THE CORPORATION OF THE CITY OF VERNON REPORT TO COUNCIL

COUNCIL MEETING: REG COW I/C
COUNCIL MEETING DATE: August 15, 2022
REPORT DATE: August 2, 2022
FILE: 3090-20 (DVP00558)

SUBJECT: DEVELOPMENT VARIANCE PERMIT APPLICATION FOR 8841 ADVENTURE BAY ROAD

Attachment 3

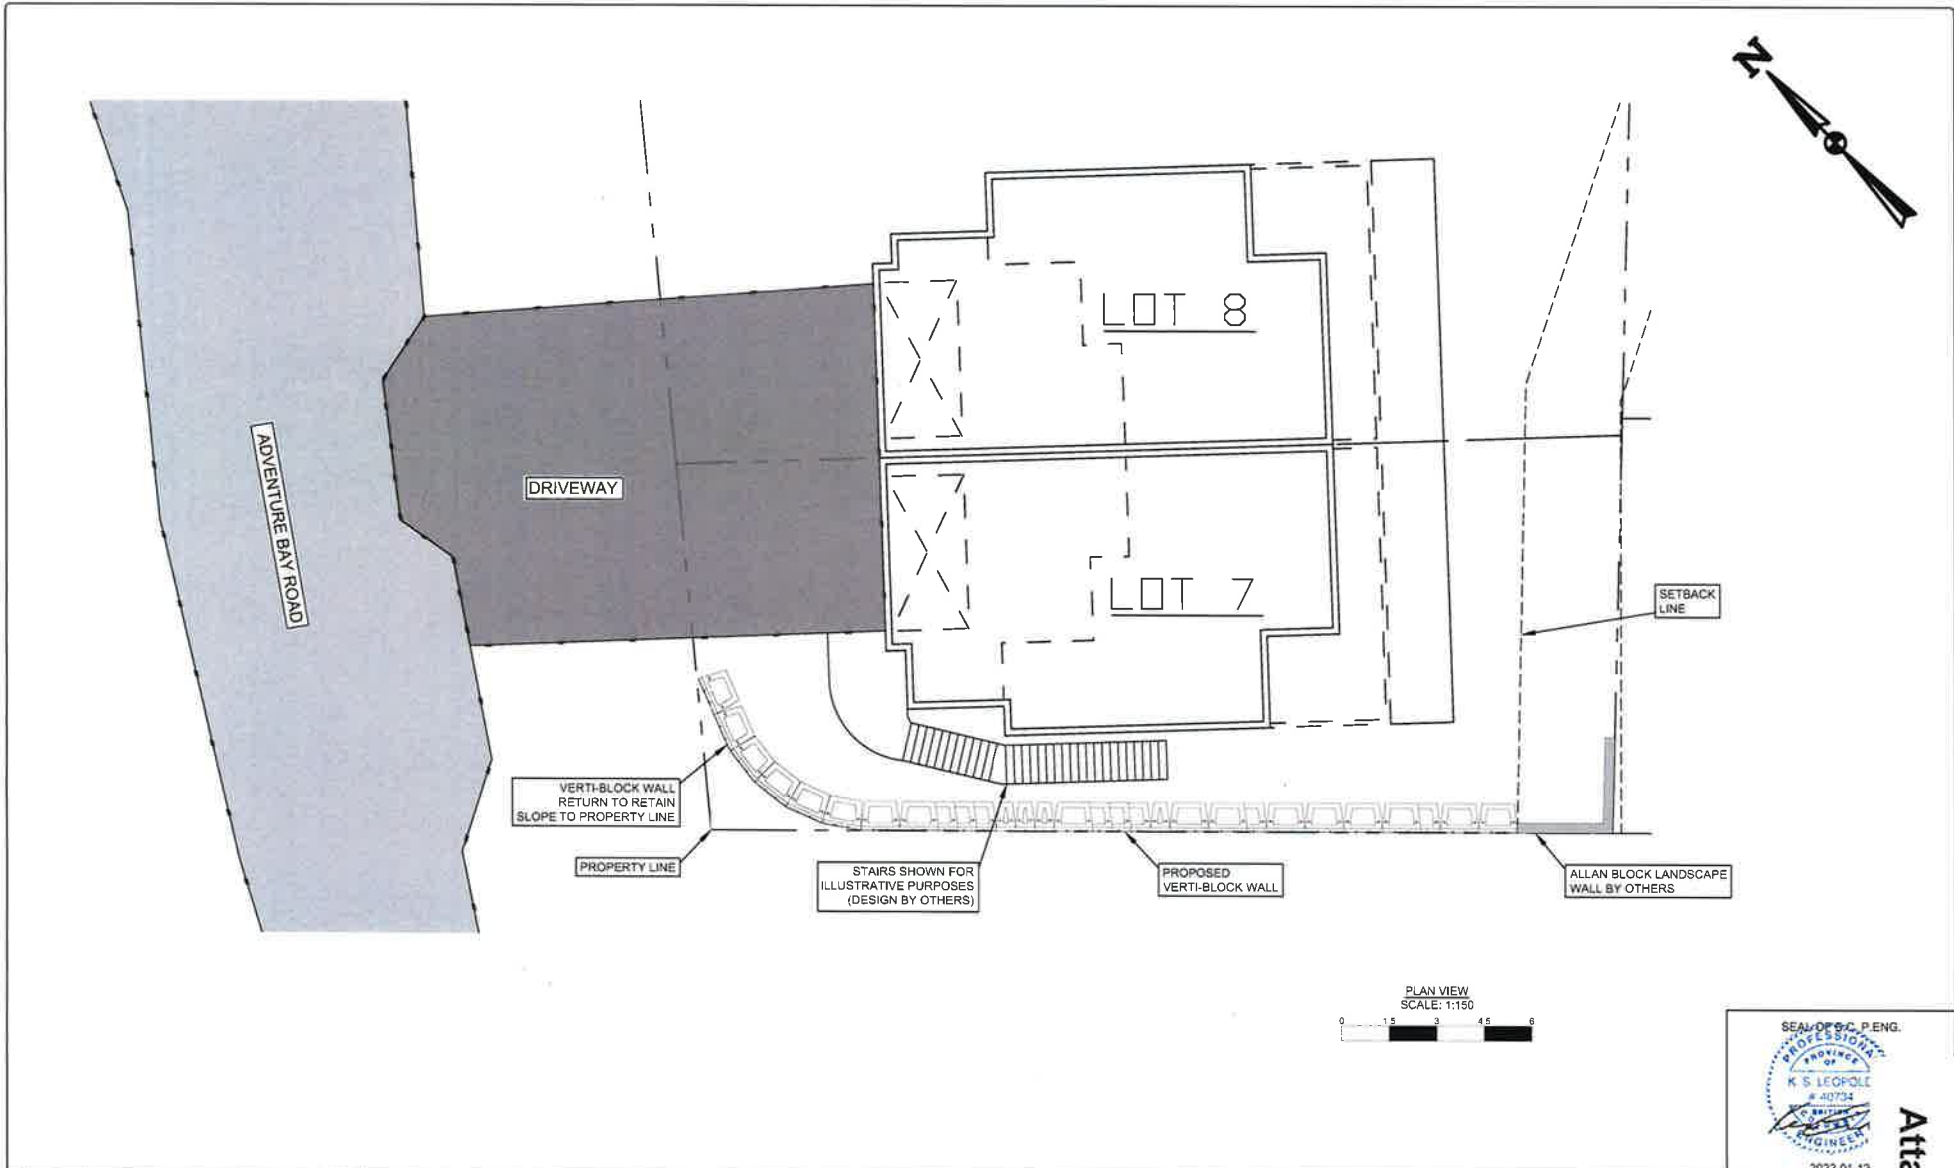
- a) That the driveway and proposed residential unit(s) be constructed to utilize the existing grade; and
- b) That the retaining wall complies with an updated site plan, elevations, and cross sections to be attached to and form part of DVP00558, with the retaining wall being setback three feet from the side property line.

- a) That the retaining wall complies with the elevations (Attachment 2), site plan (Attachment 3) and cross sections (Attachment 5) to be attached to and form part of DVP00558, except that the retaining wall be setback three feet from the property line; and
- b) That the vertical block concrete wall be stained with a color that blends in with the natural surroundings, to the satisfaction of Administration.

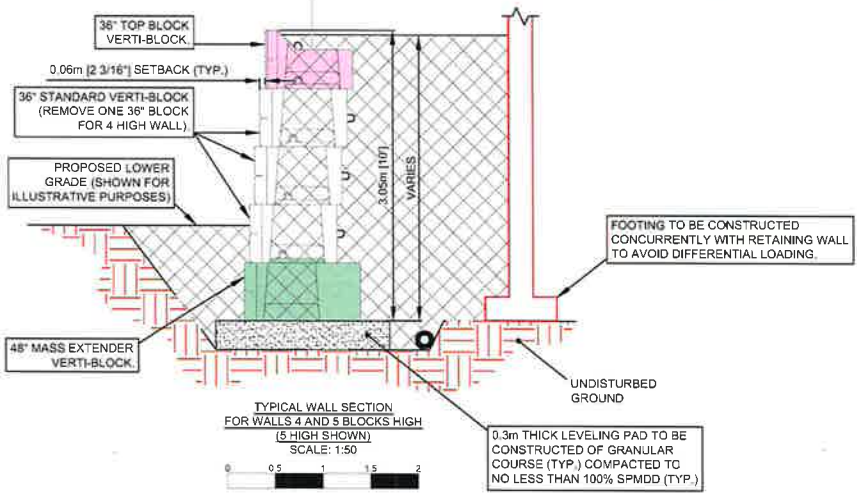
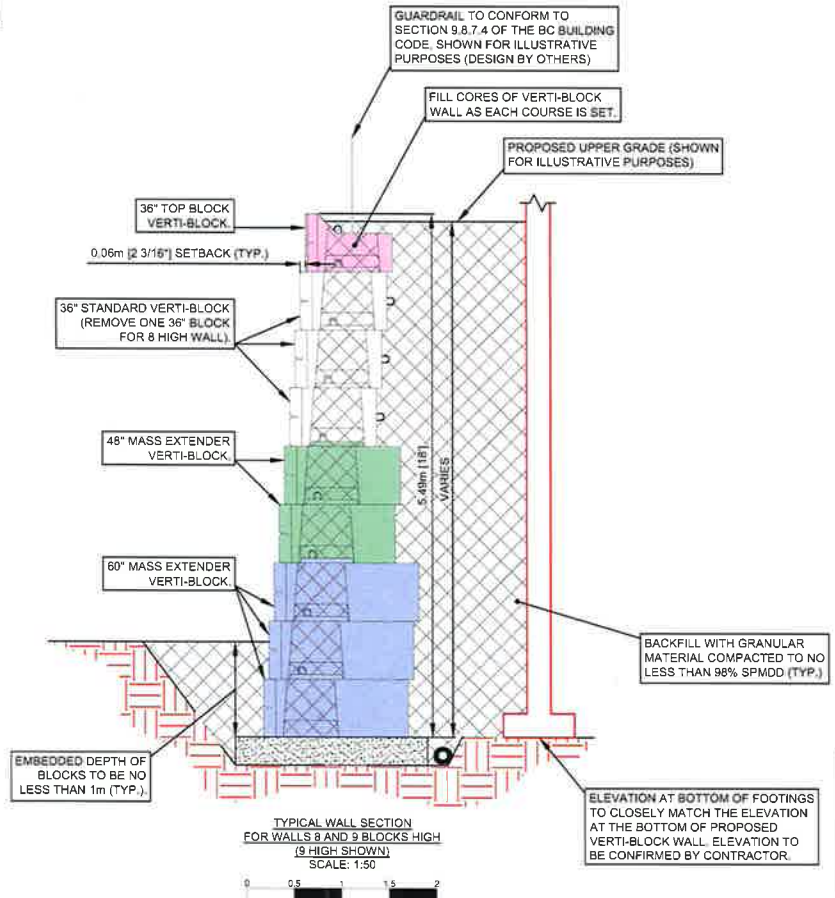
5. The proposed retaining wall consists of grey verti-blocks that are each two feet high, four feet wide, with varying depths (Attachment 5) (<https://verti-block.com/residential/>). It is possible to color stain these blocks so that they better blend in with the surroundings (<http://verti-crete.com/products/concrete-stain/>).
